**CITY OF MERIDIAN
FINDINGS OF FACT, CONCLUSIONS OF LAW
AND DECISION & ORDER**

Case No(s). H-2024-0014

COMMUNITY DEVELOPMENT DEPARTMENT REPORT

SUBJECT: [H-2024-0014](#)
Apex Farr –MDA, PP, RZ
(aka Pinnacle)

- iii. Landscape buffers to adjoining uses

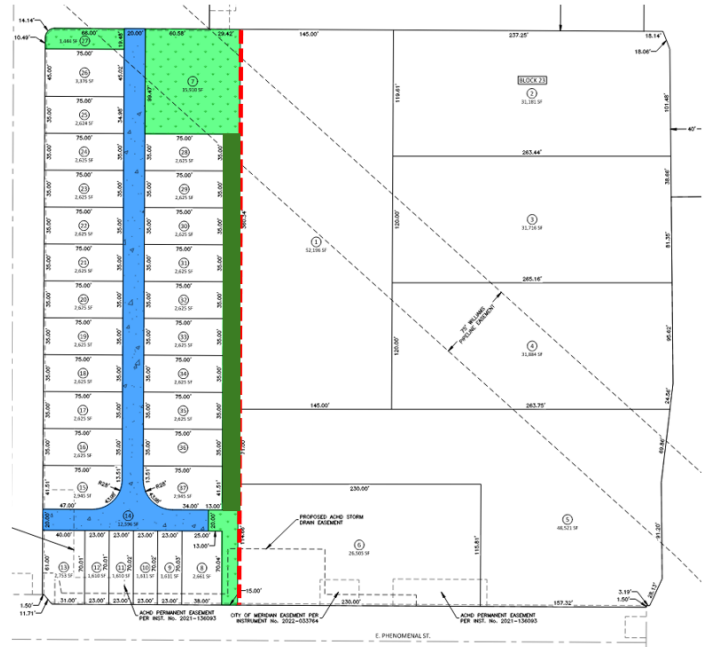
A 25-foot wide buffer is required in the C-C zoning district on Lots 1, 5 and 6, Block 23 to the abutting residential uses along the west boundary as set forth in UDC Table 11-2B-3.

The Applicant requests City Council approval of *no* buffer in this area with the provision of a 15-foot wide common area mew on the residential portion, which will include landscaping and a sidewalk as shown in the exhibit below. The Applicant asserts the mew will act as a buffer that still provides connectivity to the adjoining uses and walkability to the adjoining commercial uses to the east in accord with the MU-C FLUM designation. Staff recommends if Council is amendable to the Applicant's request that the common area mew is increased to a minimum of 20-foot wide consistent with the linear open space standards in UDC [11-3G-3B.1e](#) and includes landscaping in accord with the standards for landscape buffers to adjoining uses listed in UDC [11-3B-9C](#). If Council grants the request, a reduction to the buffer width shall not affect building setbacks; all structures shall be set back from the property line a minimum of the buffer width (i.e. 25-feet) required in the C-C zoning district.

As an alternative to the Applicant's request, ~~which would require no buffer on the C-C zoned property~~, Staff recommends a public street is provided between the residential and

commercial portions of Block 23 and an alley is provided for access to the residential units rather than a private street. The addition of a public street will provide a named street for addressing the east-facing units, provide for on-street parking for guests of the residential units and provide a transition/separation between land uses and Staff's original recommendation to provide a public street between the residential and commercial uses, which doesn't meet ACHD's off-set requirements, Staff recommends residential lots/uses are removed from Block 23 and all of Block 23 is developed with commercial uses and zoned C-C. See concept layout below in Section III.E.1.

Access (*Comp Plan, UDC 11-3A-3, UDC 11-3H-4*):

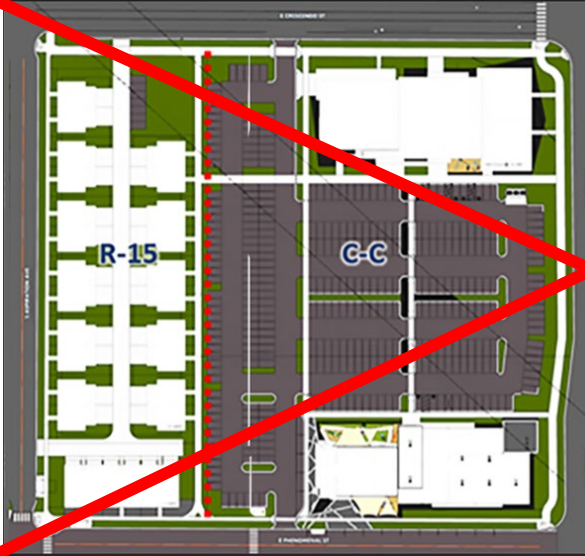
1. Access is proposed via the extension of E. Quartz Creek St., E. Tranton St. ~~and E. Liberator Ct.~~ at the project's west boundary; and from S. Locust Grove Rd. via S. Apex Way and E. Crescendo St. An emergency access is proposed at the north boundary via S. Margaret Ave. East Liberator Ct. stubs to the northwest boundary of the site but due to the slope in that area, that street is not proposed to be extended with development.

The north/south drive depicted on the plat that provides access to the residential lots in Block 23 should be realigned to reflect the updated design shown on the landscape plan. Staff is *not* in favor of the proposed layout of this block with the residential units abutting the parking lot for the commercial area with only 15-feet in between consisting of landscaping and a pathway. ~~Accordingly, Staff recommends the access drive for the residential units is constructed as an alley and a north/south public street is provided between the residential and the commercial lots for addressing purposes for the east-facing residential units, for on-street parking for the residential units and as a transition/separation between land uses. The following is the existing layout and a concept layout showing Staff's recommended changes: Because Staff's original recommendation to provide a local street between the residential and commercial uses doesn't meet ACHD's off-set policy, Staff recommends the residential lots/uses are removed from Block 23 and all of Block 23 is developed with commercial uses and zoned C-C.~~

- ix. Revise the alignment of the north/south drive that provides access to the residential lots in Block 23 to reflect the updated layout shown on the landscape plan.
